TECHNICAL NOTES SERIES

JOWETT JAVELIN – PA, PB, PC, PD & PE

JOWETT JUPITER – SA & SC

PART III – SERVICE BULLETINS – JAVELIN AND JUPITER

Figure 1. Arrangement of roller bearing conversion.

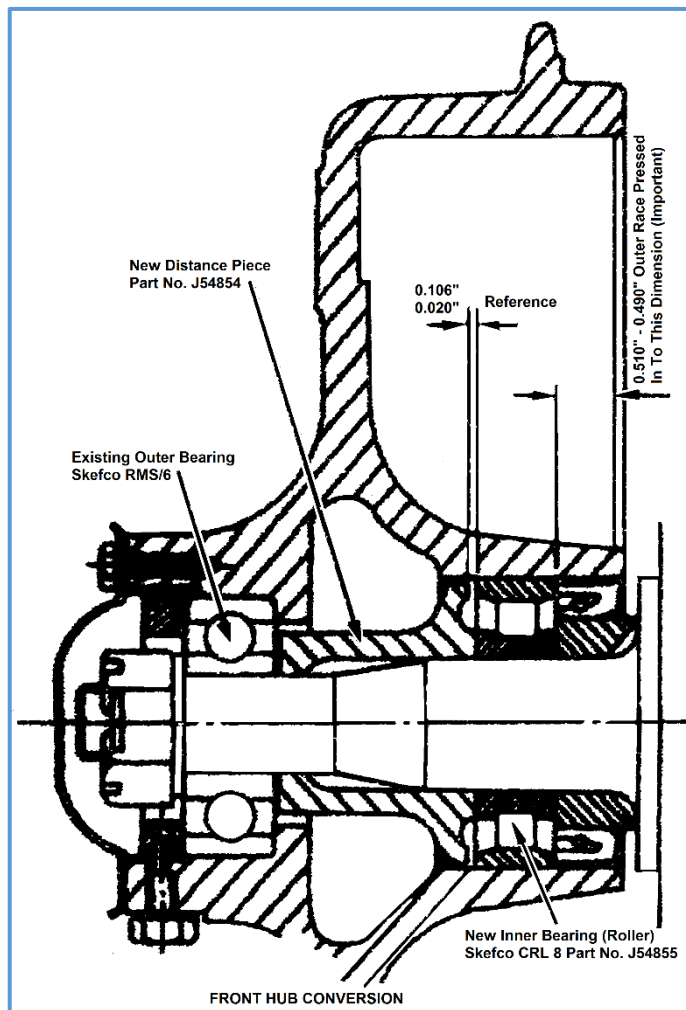
This scheme involves the changing of the inner bearing, which is of the ball type, to a roller bearing, Part Number J54855 (Skefco CRL 8), and also the distance piece to the new type, Part Number J54854. When fitting the new bearing, attention must be paid to the dimensions required when pressing the roller bearing into position, refer to *Figure 1*. The outer ball bearing, Skefco RMS/6, remains unchanged.

The roller type bearings and distance piece can be fitted to all hubs after Engine Number E0 PB 10594 (Javelin) and Engine Number E0 SA 56 (Jupiter), the new type distance piece must be used.
